Department of Transportation
Technical Services
Roadway Engineering Section
355 Capitol Street NE, Room 222
Salem, OR 97301-3871
Telephone 503-986-3714
FAX 503-986-3749

Addenda No. 2

SUBJECT: Bay Blvd Sidewalk, Lights, & Paving (Newport) Section
SW Bay Boulevard
Lincoln County
(Bids to be opened and read July 16, 2009)

SHEET NO. 2E-4

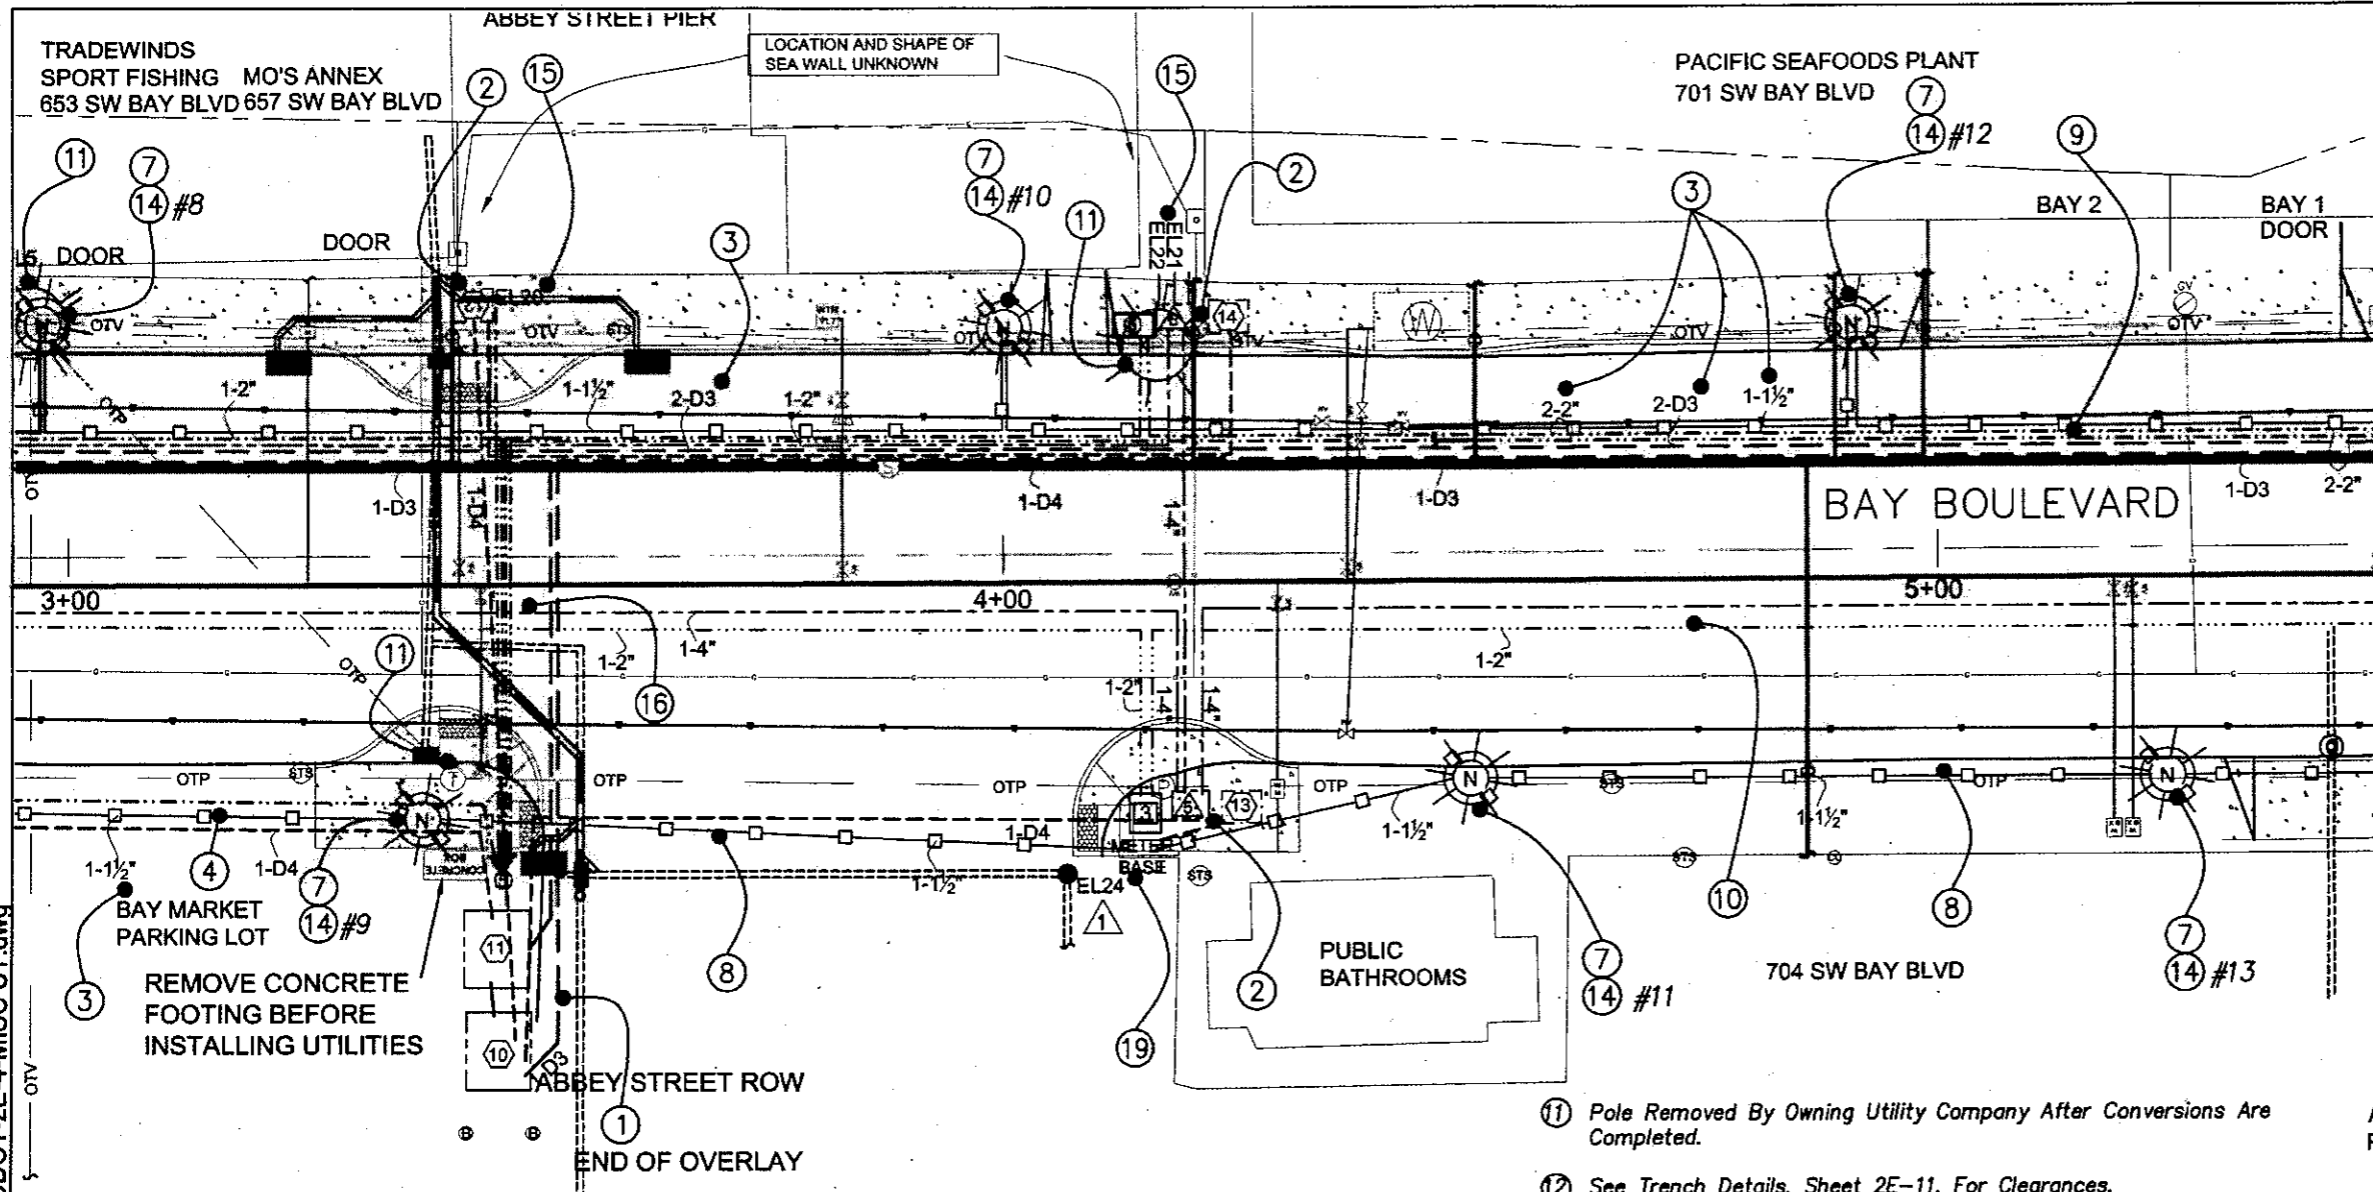
REVISIONS	
①	REVISED 7-8-2009 ADDED EL24 AND CONDUIT FROM VAULT 13
②

SHEET NO. 2E-5 **MISC. UTILITIES**

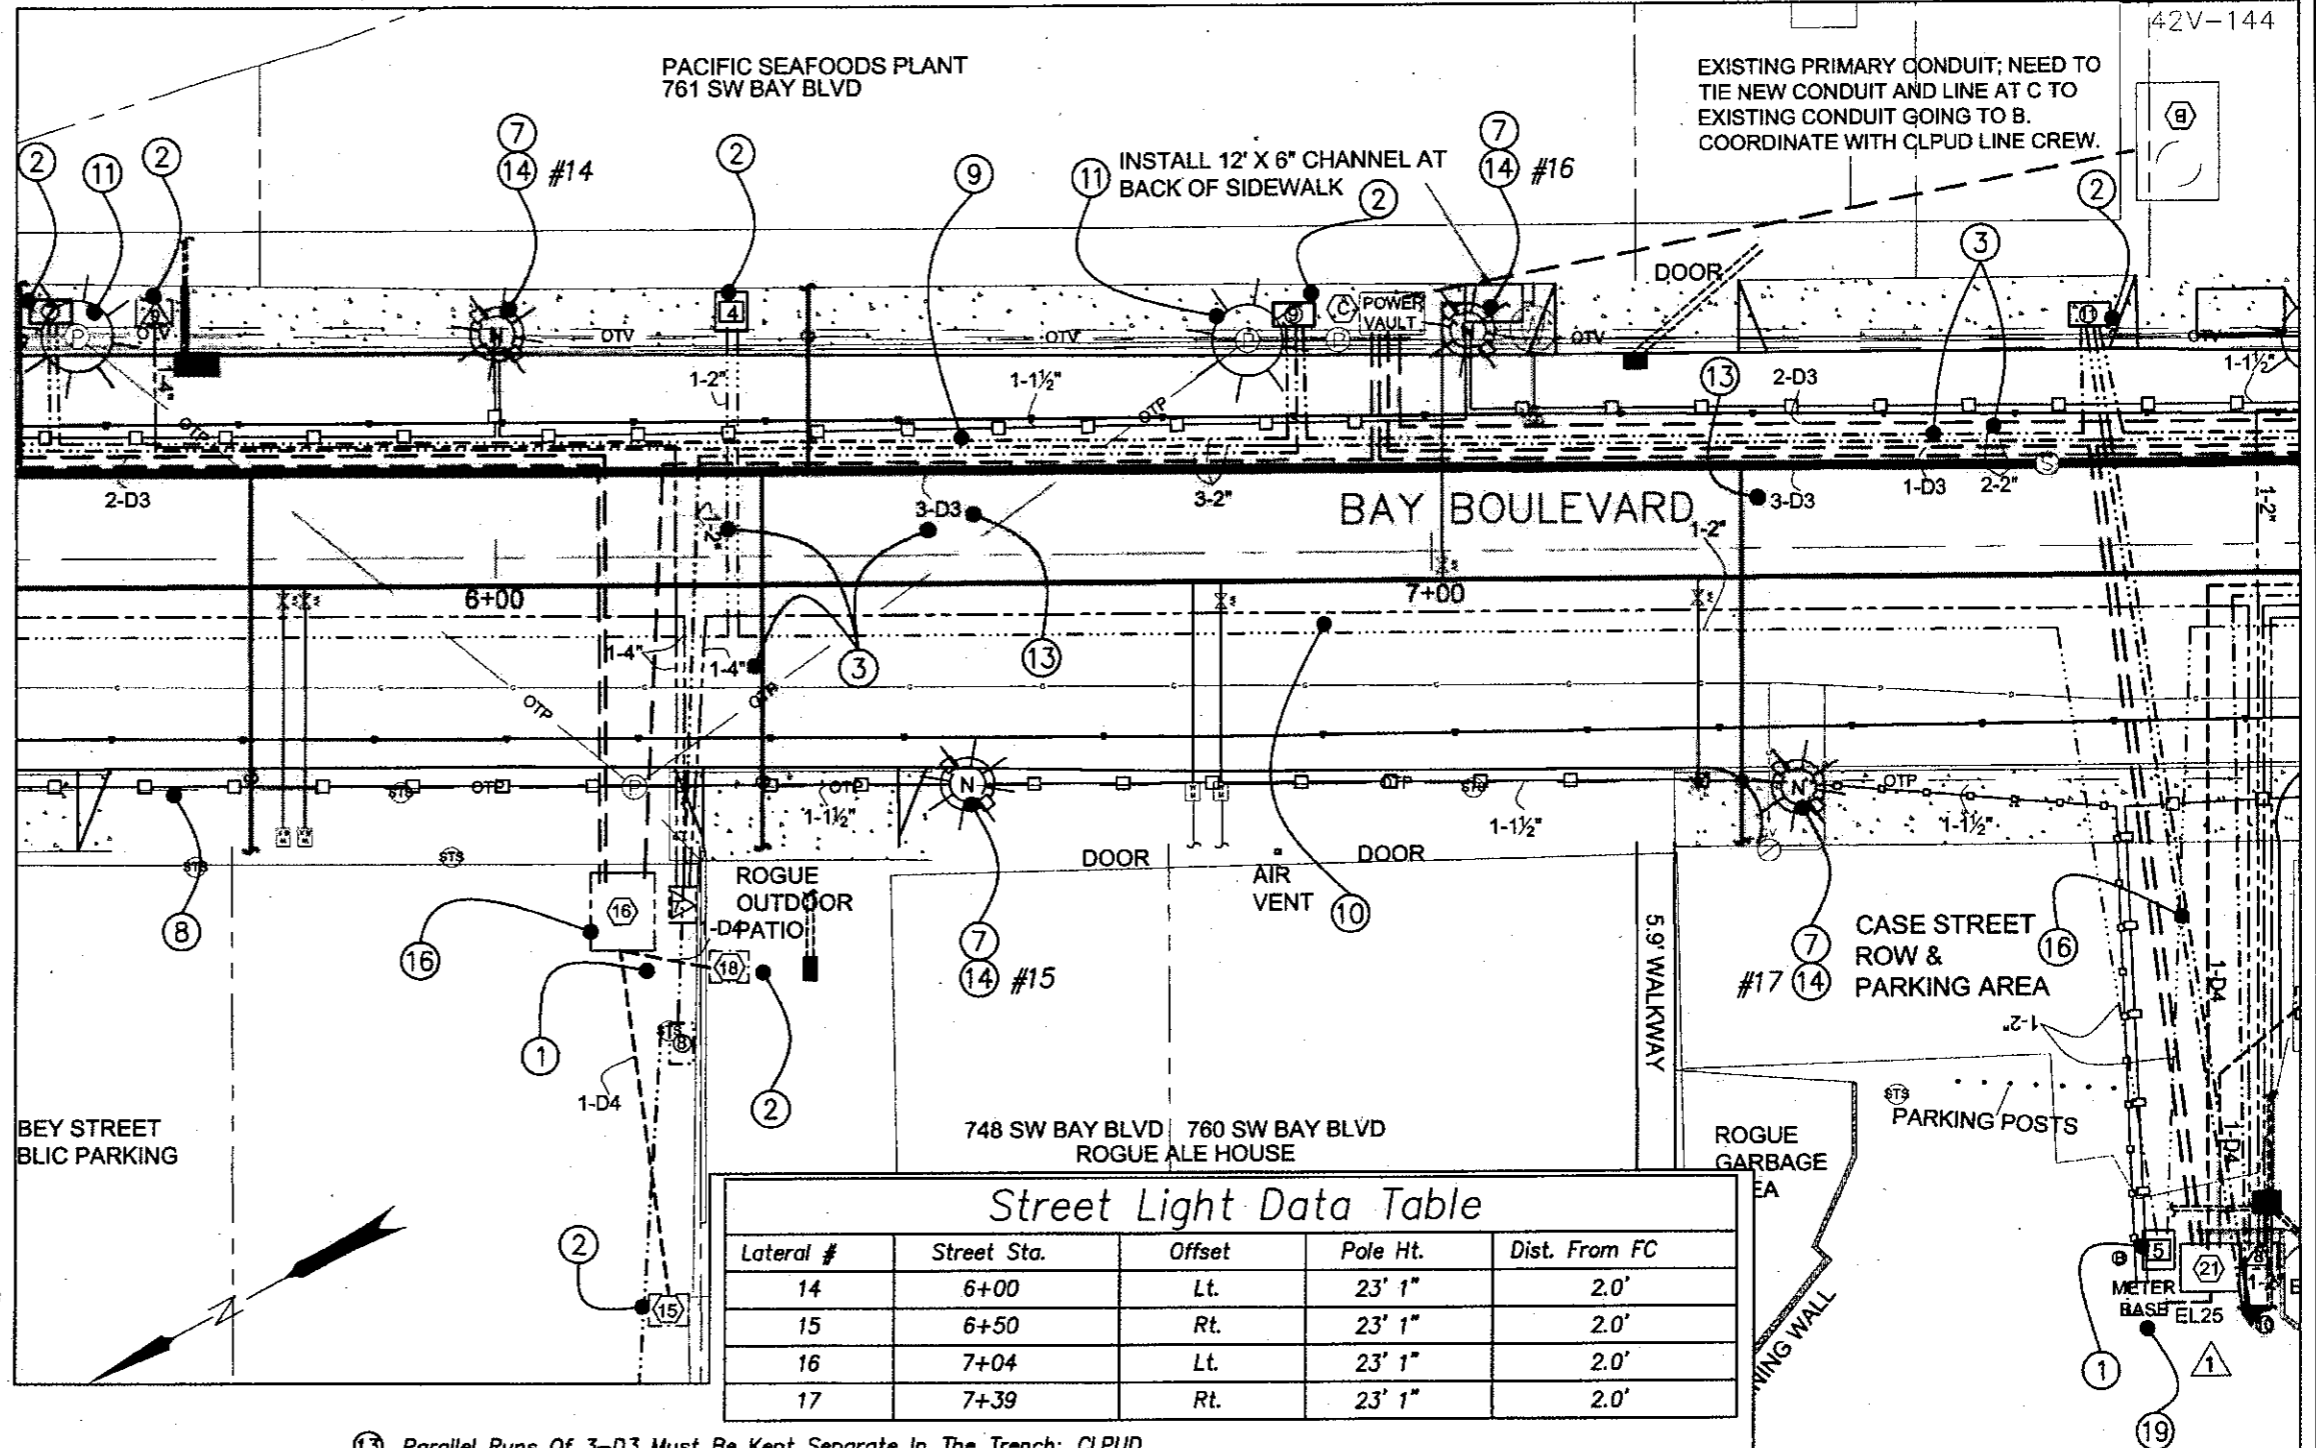
REVISIONS	
1	REVISED 7-8-2009 ADDED EL25 AND CONDUIT FROM VAULT 21

SHEET NO. **2E-7**

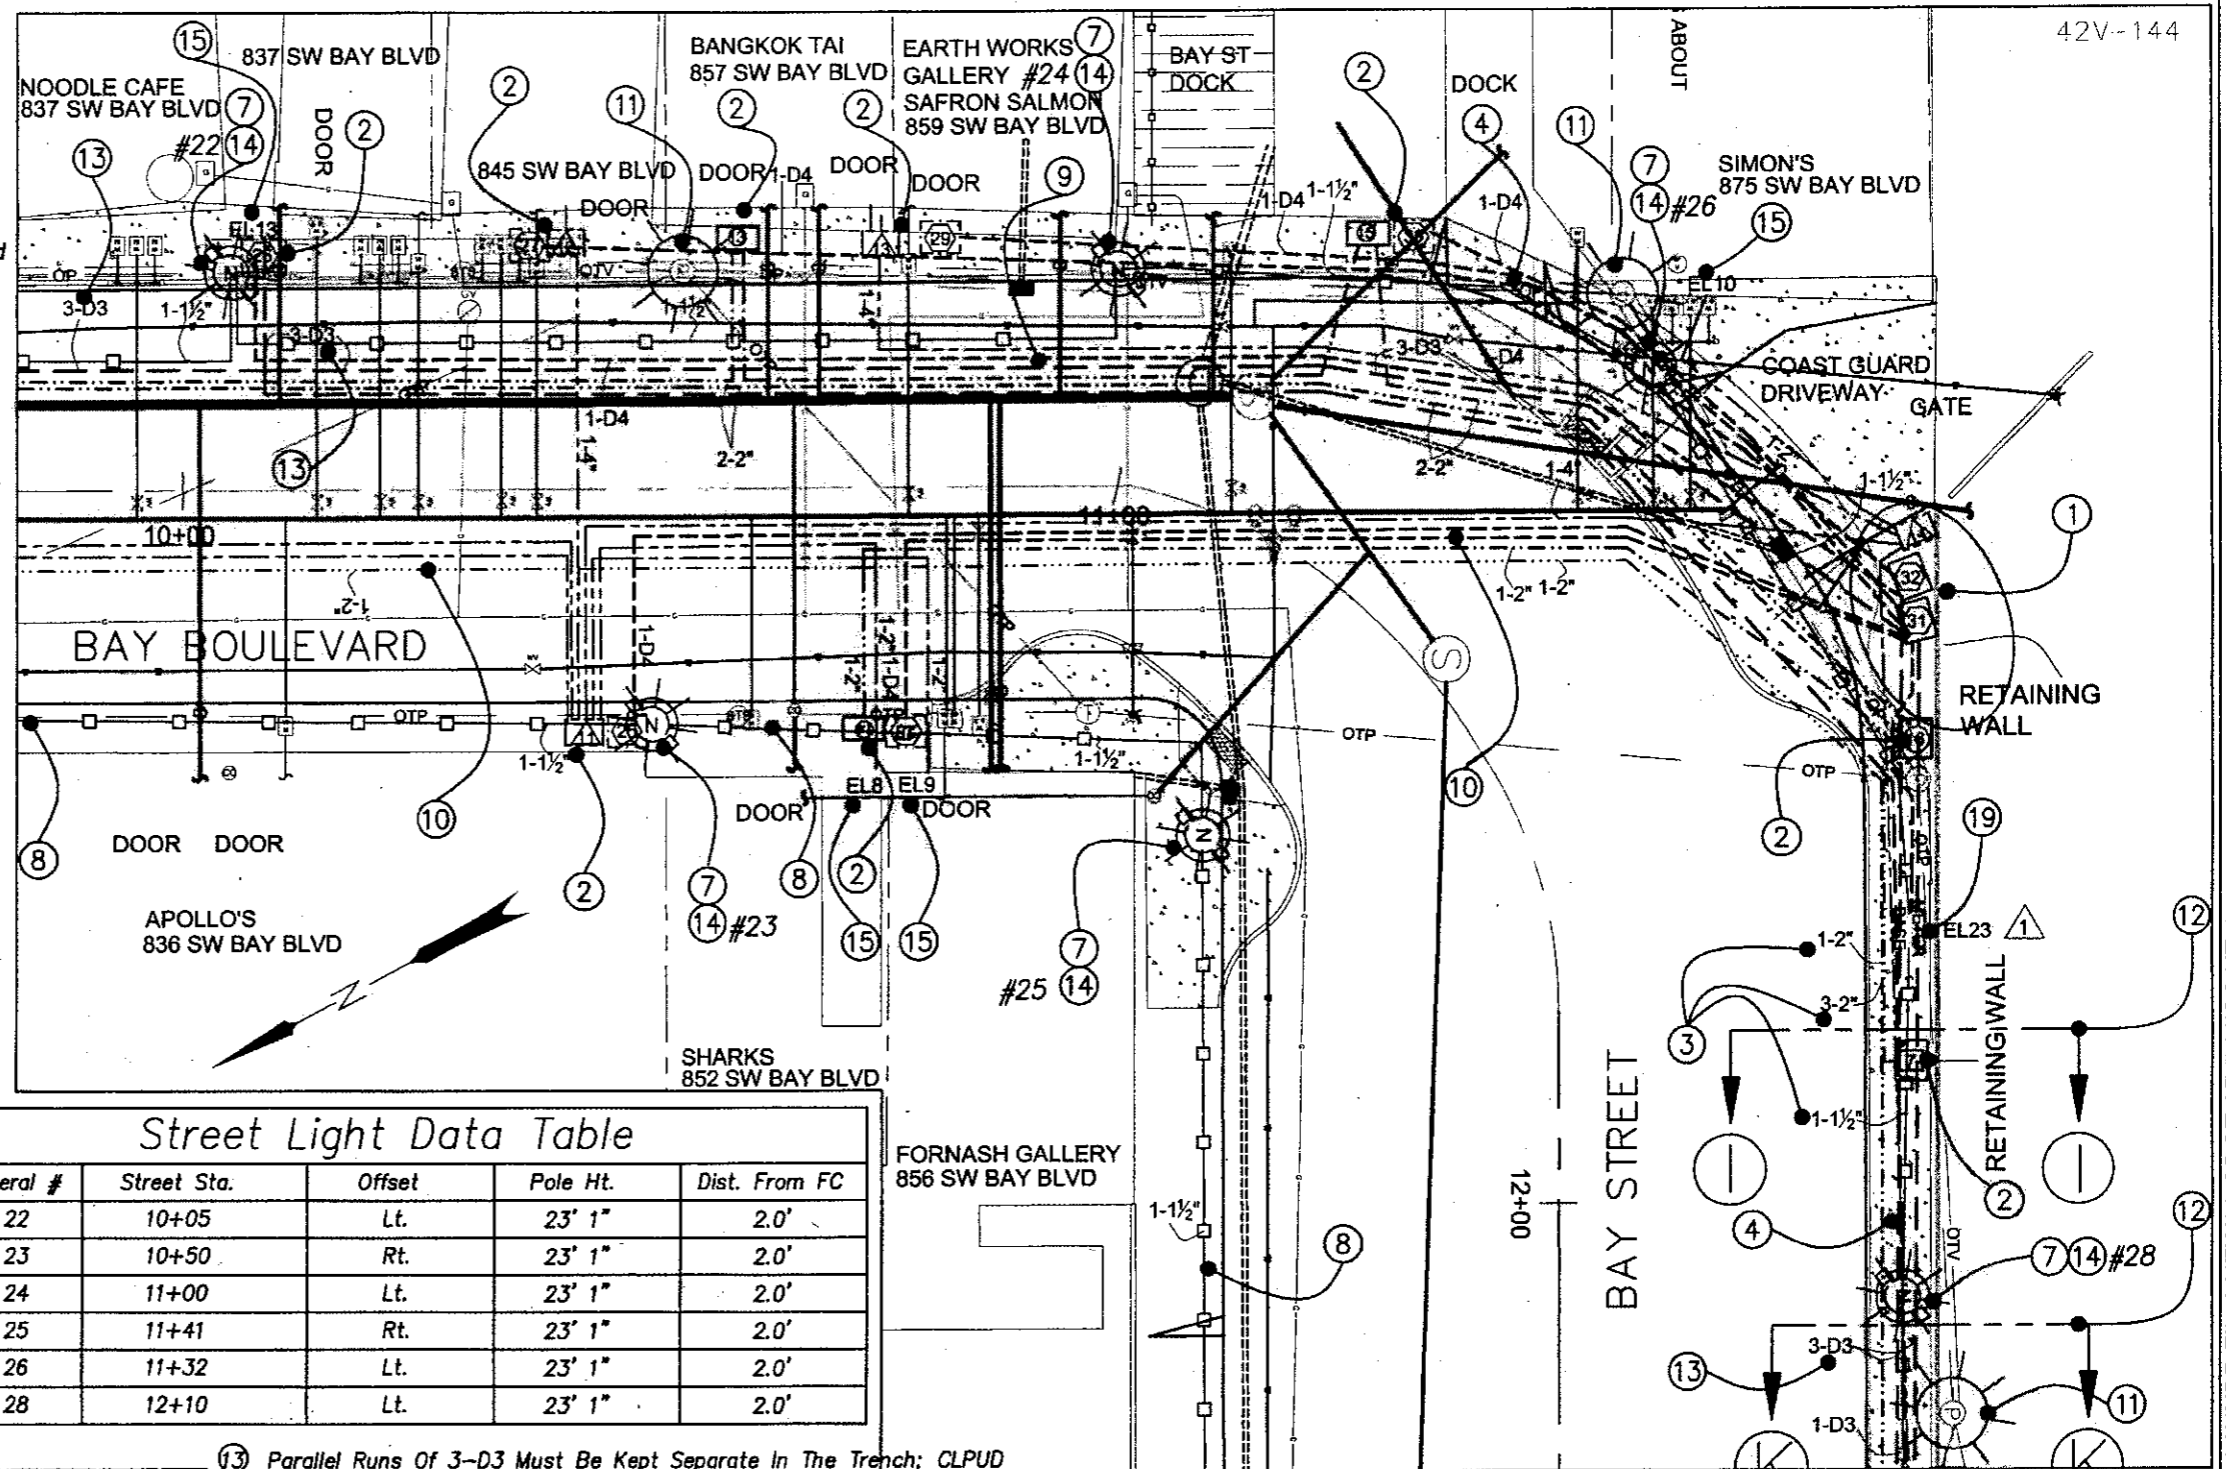
| ① | REVISED 7-8-2009

ADDED EL23 AND CONDUIT FROM VAULT 31 |
